MEMORANDUM

From:	Brigitte Crafer Landscape Architect		
Service	WBC Landscape and Trees	App No:	241900
Address:	Land South of Old Bath Road Sonning, RG4 6GQ.		
Proposal:	Application to vary condition 2 of planning consent 220663 for the proposed erection of 57 dwellings suitable for older persons accommodation following demolition of the existing dwellings (Access, Layout, Scale and appearance to be considered). Condition 2 refers to approved plans and details and the variation is to change the site layout and associated details.		
Type of Development:	Major Dwellings (10+)		
Site Visit Made:	Yes/No

Fig. 2 – Re-configuration of garden area between Block A and B and revised parking arrangement, showing 5th parking bay and impact on T68

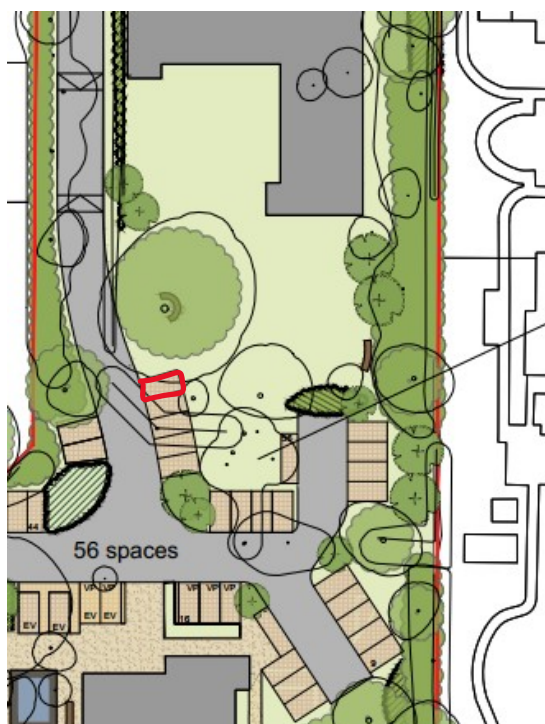
This is an improvement on the previous arrangement but there is still more of an incursion into the RPA of T68 by the northern parking bay of 5 – and this is more incursion into another protected tree which is unnecessary and needs to be reviewed.
